Siskiyou County Supervisors Meeting, 05/07/2024
RE: Appeal of Golden Eagle Charter School, Use Permit UP-23-08/Addendum
to Certified Mitigated Negative Declaration

REPORT ABOUT PROJECT'S SIGNIFICANT LIGHTING IMPACTS

Figure 3a –Golden Eagle’s 2020 Preliminary Lighting Plan for its Pine Street School Site.

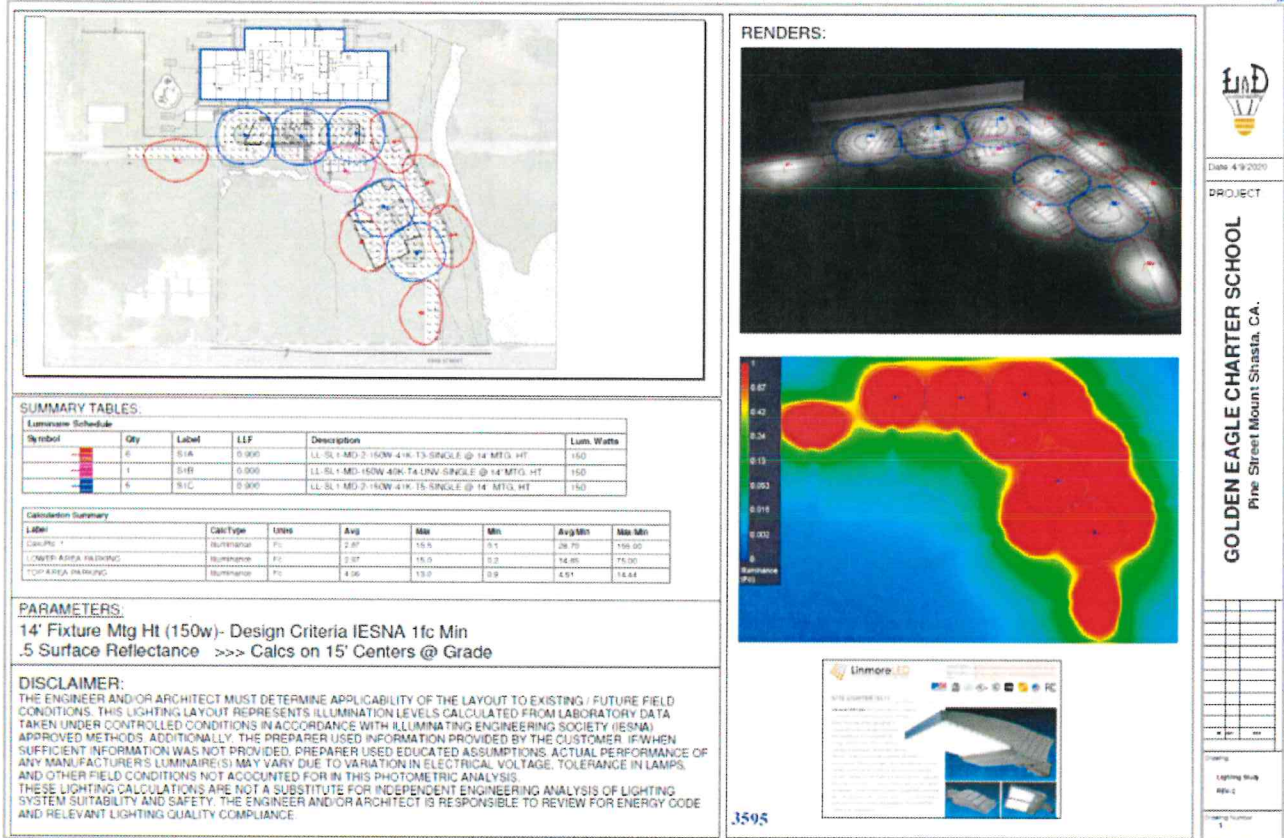
Nor did that 2020 “Preliminary Lighting Plan” compare its computerized lighting levels for the parking lot to any thresholds of significance or standards for illuminance. CEQA requires such a study to explain in plain English its analysis of the interpretation of its technical information. Parking lot lighting levels as Golden Eagle proposed would have been too bright though, based upon recommendations from the International Dark Sky Association (ISDA). The County does not have its own threshold of significance for parking lot lighting levels, so according to CEQA, other standards are appropriate to reference here.

That previous 2020 GECS Preliminary Lighting Plan showed that the average lighting level in the proposed parking lot areas **would be about 4 to 8 times brighter than recommended by the ISDA.** This is a table from the first page of that Preliminary Lighting Plan above:

This table indicates the average brightness (illuminance, in footcandles) for Golden Eagle’s parking lot lighting would have been between 2.97 to 4.06 foot-candles. That lighting level is excessive, wasteful of energy, and harmful to neighbors. People do not need parking lot lighting to be that bright for safety at night. That number may not mean much to the average person, but it is excessive by

standards set by the International Dark Sky Association for parking lot illumination. Those IDSA standards recommend that public and private parking lots not exceed 0.8 and 0.5 foot-candles respectively.² Accordingly, if GECS installs what it proposed a few years ago for its previous school site, the new Project's average lighting levels would be from about **4 to 8 times brighter** than what the International Dark Sky Society recommends as a maximum illumination level. Exceeding such a well known lighting standard by that degree is evidence of a potentially significant lighting impact.

Figure 3b –April 9, 2020 Preliminary Lighting Plan for Golden Eagle’s Pine Street Site

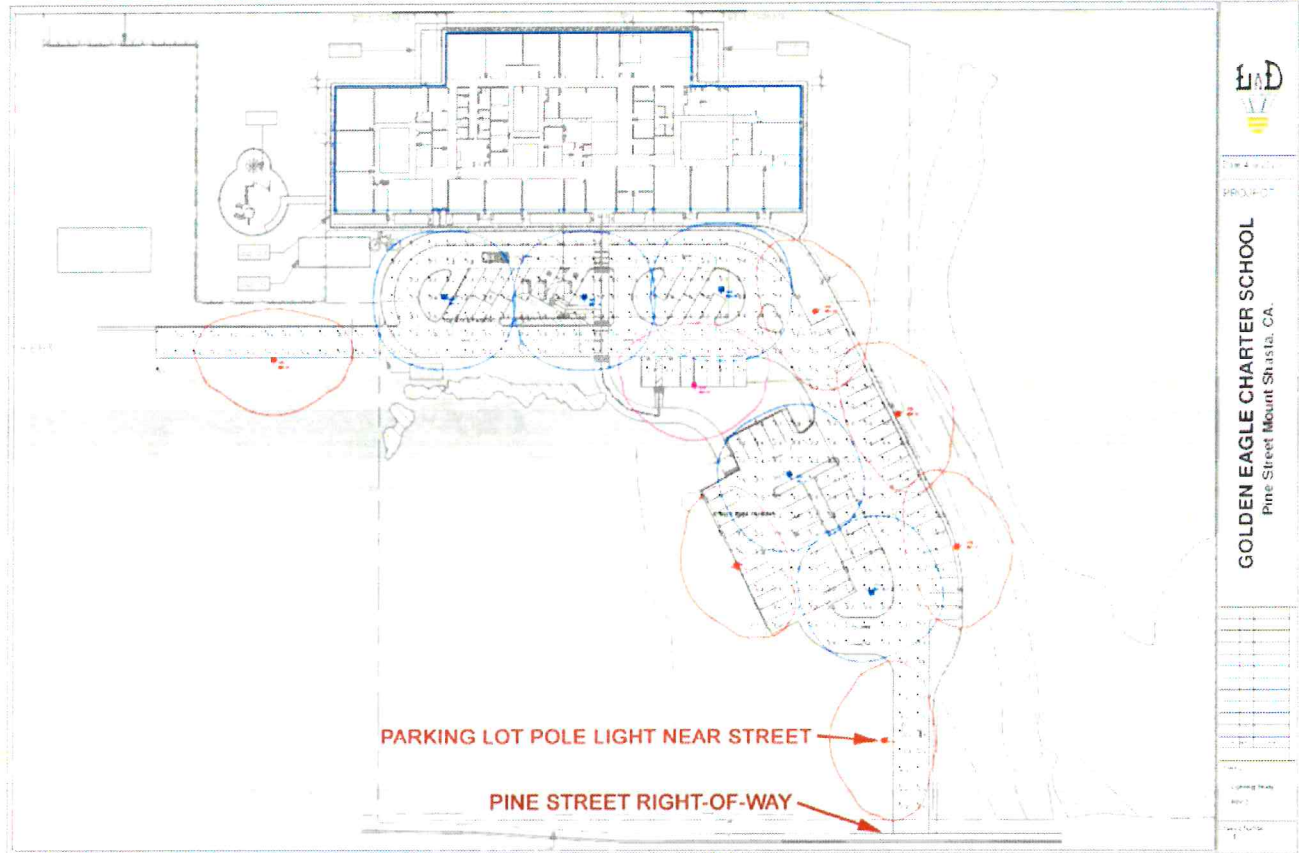
The IES and its standards are relevant because the IES was referenced in GECS's previous Preliminary Lighting Plan. But that Preliminary Lighting Plan's *Disclaimer* section acknowledged that that lighting plan provided no guarantee of compatibility or suitability for that particular Mt. Shasta site. It instead left that up to the Project's architect or engineer. The previous Preliminary Lighting Plan, p. 2, *Disclaimer* stated:

"These lighting calculations are not a substitute for independent engineering analysis of lighting system suitability and safety. The engineer and/or architect is responsible to review for energy code and relevant lighting quality compliance."

Figure 4 – Clip from GECS's 2020 Preliminary Lighting Plan Showing Light Near Street

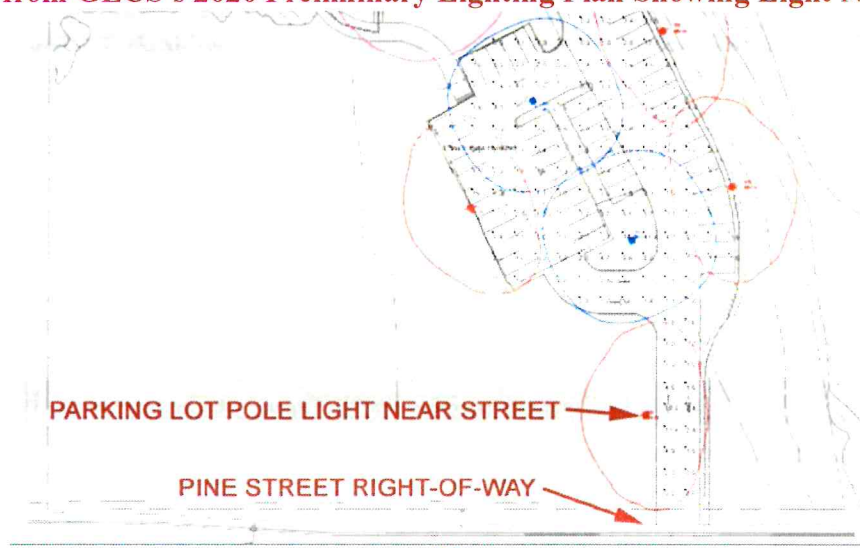
Golden Eagle may install a parking lot pole lamp even closer to W.A. Barr Road than currently exists. A new overly-bright, excessively tall, and inadequately shielded pole light fixture there near the road could cause safety hazards to motorists or other people that does not currently exist. That very real risk could occur because, with a newly-configured double driveway intersecting with the road, Golden Eagle may need more driveway lighting there than did the previous church. The existing parking lot pole light (#1 in photo above) is about 100 feet from W.A. Barr Road. But that existing parking lot pole light is too far away to illuminate the driveway's intersection with the road. As shown on Golden Eagle's previously-proposed 2020 Preliminary Lighting Plan for its other Pine Street site, it then proposed a parking lot pole light at about half that distance from the road:

Figure 5 - A Portion of the Site Plan for the Golden Eagle Charter School Project Showing A Double Driveway Design that was Never Circulated for Public Review

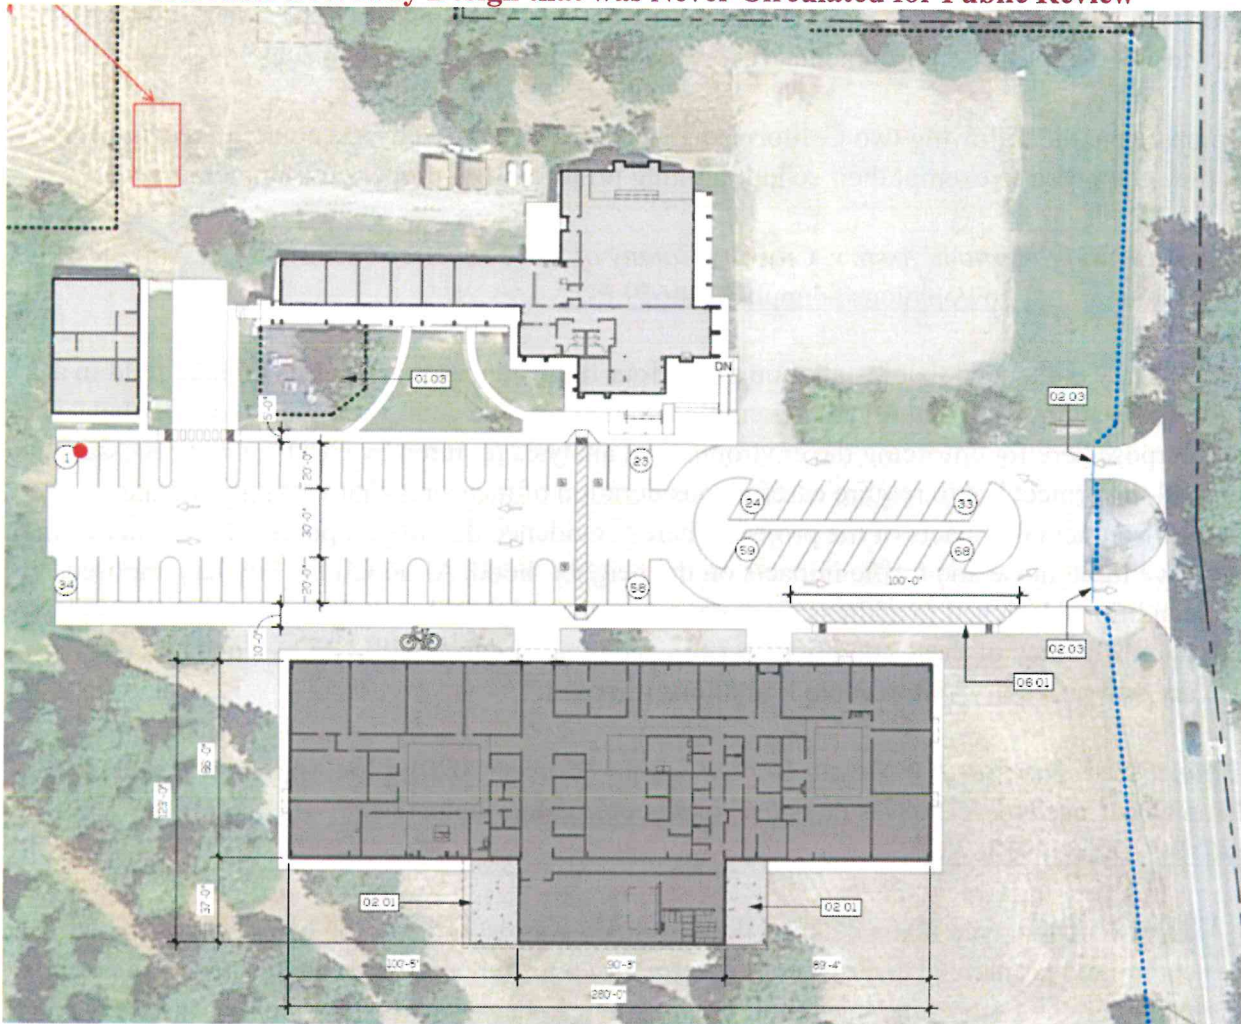
On the next page is the final Site Plan that the Planning Commission approved for Golden Eagle's project. This Site Plan included for the first time two separate driveways for the school's access from W.A. Barr Road. New lighting will be needed for this driveway design at the road because this design poses traffic safety risks in the dark that were never evaluated within a licensed traffic engineer's report. For example, a north-bound motorist on W.A. Barr Road intending to turn into the school's northern driveway might cross paths with a vehicle or student exiting the southern driveway

and turning left.
